Staff Report to the Plan Commission
Founders of Orland Park Residential Planned Development
Prepared: 11/14/2024

Project: 2023-0309 – Founders of Orland Park
Petitioner: John McHale, Bridge Street Properties, LLC.
Project Representative: Caitlin Csuk, Rosanova & Whitaker, Ltd.
Location: 16101-11 Wolf Road
P.I.N.s: 27-20-101-013-0000, 27-20-101-011-0000
Parcel Size: approximately 15 acres

Founders of Orland Preliminary Site Plan

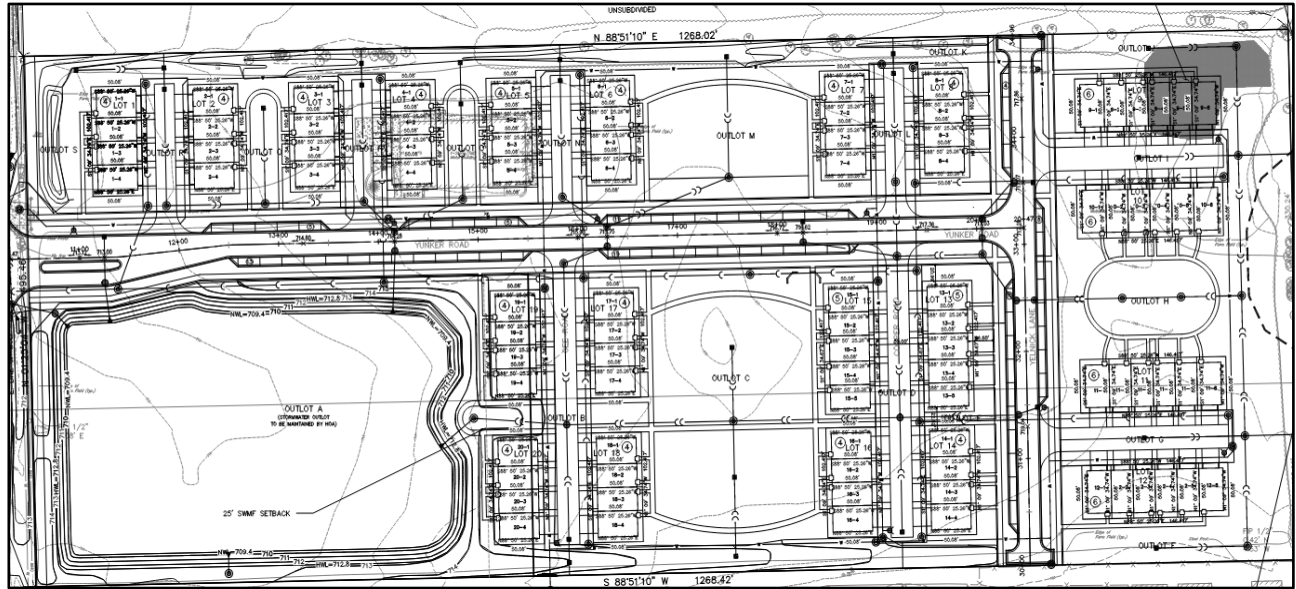
The 15-acre proposed site plan includes 90 three-bedroom townhomes arranged along two public streets, with the primary access point from Wolf Road. Yunker Road, functioning as the main throughfare, is designed in a boulevard style, featuring on-street parking, curb bump-outs, and parkway trees. Yelnick Lane, a north-south street on the eastern side of the site, is developed as a stub street at the north and south property lines to allow for future connections to neighboring developments. The site also includes a large stormwater management area and multiple park areas to be owned and maintained by a common homeowners association.

The R-4 Residential District allows for a maximum of 6 dwelling units per net acre within a residential Planned Development. The proposed plan shows 6 units per gross acre and 7.7 dwelling units per net acre.

Modification #1: Allow for an increase in density from 6 dwelling units per net acre to 7.7 dwelling units per net acre.

The petitioner has requested a modification to the Special Use for a Planned Development to account for a density increase of 1.7 units per acre. The petitioner has submitted responses to the Modification Standards Worksheet within their Petition for Development (attached) on pages 14-17. This adjustment has been requested because 3.44 acres of the site are dedicated to stormwater management, which is excluded from the density calculation for dwelling units per acre.

In December 2023, the Plan Commission unanimously recommended approval of Case Number 2023-0996, a code amendment to eliminate the use of net buildable acres in density calculations within the LDC, allowing the calculation to be on a units per gross acre formula; however, the Board of Trustees later rejected this amendment. Due to this denial, staff cannot support the requested density increase for this case.

Staff Recommends the Plan Commission **denies** the modification to allow for an increase in density from 6 dwelling units per net acre to 7.7 dwelling units per net acre.
